<b>PCN Number:</b>	20161114000	<b>PCN Date:</b>	Nov 15, 2016
<b>Title:</b>	ADC32xx/34xx Product Family Design Change		
<b>Customer Contact:</b>	<a href="#">PCN Manager</a>	<b>Dept:</b>	Quality Services
<b>Proposed 1<sup>st</sup> Ship Date:</b>	Nov 15, 2016	<b>Estimated Sample Availability:</b>	Date provided at sample request
<b>Change Type:</b>			
<input type="checkbox"/>	Assembly Site	<input type="checkbox"/>	Assembly Process
<input checked="" type="checkbox"/>	Design	<input type="checkbox"/>	Electrical Specification
<input type="checkbox"/>	Test Site	<input type="checkbox"/>	Packing/Shipping/Labeling
<input type="checkbox"/>	Wafer Bump Site	<input type="checkbox"/>	Wafer Bump Material
<input type="checkbox"/>	Wafer Fab Site	<input type="checkbox"/>	Wafer Fab Materials
<input type="checkbox"/>	Software	<input type="checkbox"/>	Part number change
<input type="checkbox"/>		<input type="checkbox"/>	Assembly Materials

Texas Instruments Incorporated is announcing an information only notification for a design change on the ADC32xx/34xx product family of devices.

Figure 1 Glitch on ADC reference voltage

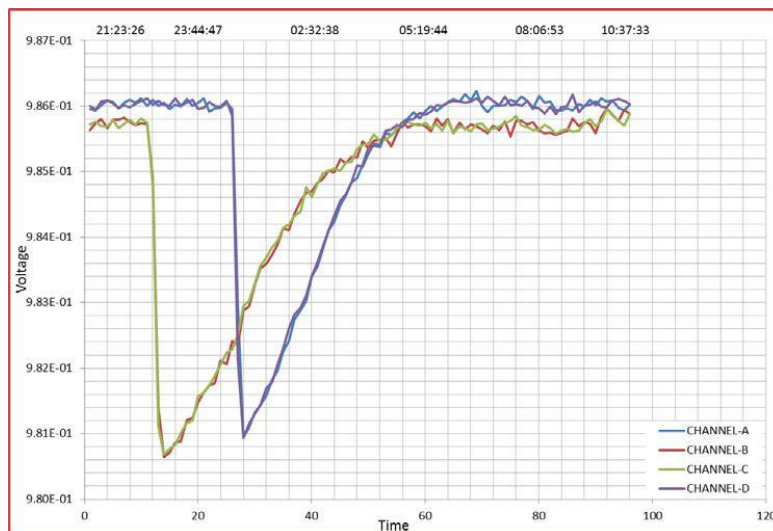
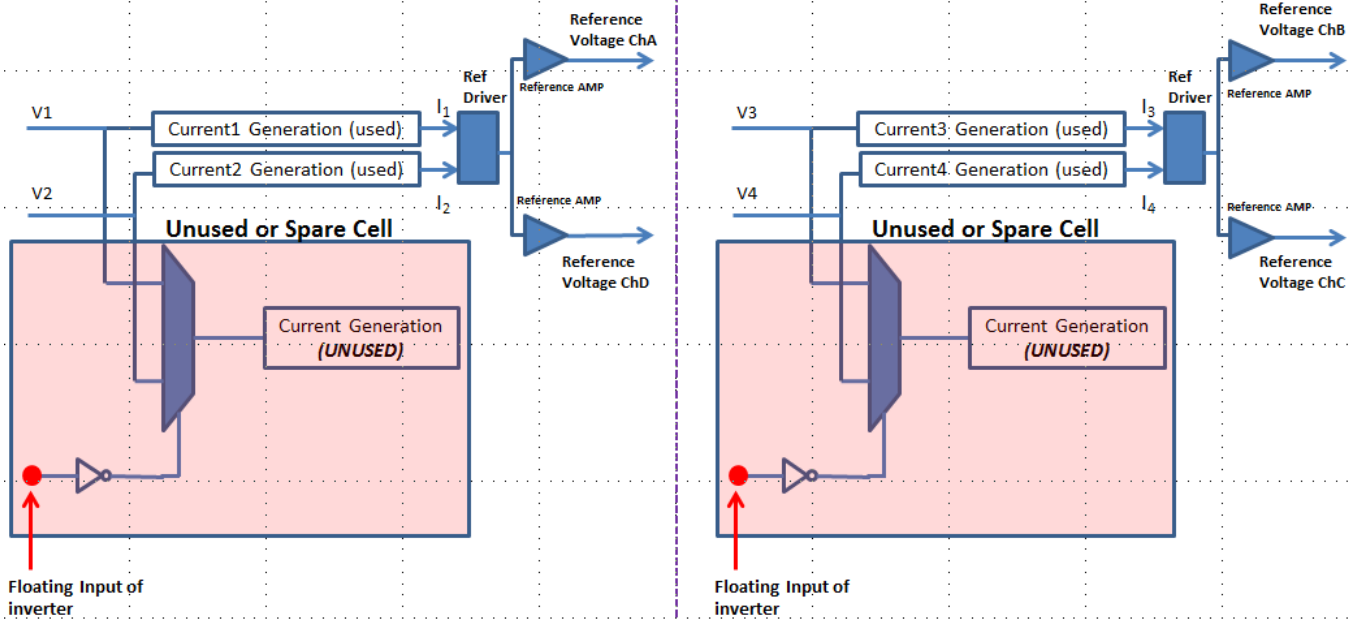
1. ADC's gain error (1) shows a 'glitch' when a fresh device is tested.
  - a. For quad channel part (ADC34xx/34Jxx), channel A and D show the glitch together, while channel B and C show it together. For dual channel part (ADC32xx/32Jxx), glitch occurs at the same time for channel A and B.
  - b. When glitch occurs, the gain error increases by ~0.5%.
  - c. The glitch shows a very slow settling profile with a time constant of 'hours'.
  - d. Once settled, the glitch doesn't occur again, i.e. the glitch occur only once for a given device.
  - e. This issue doesn't cause any impact on AC performance.
  - f. The issue affects only time-domain applications.
2. Lab test show that glitch in gain error is a result of glitch in ADC's reference voltage as shown in figure 1
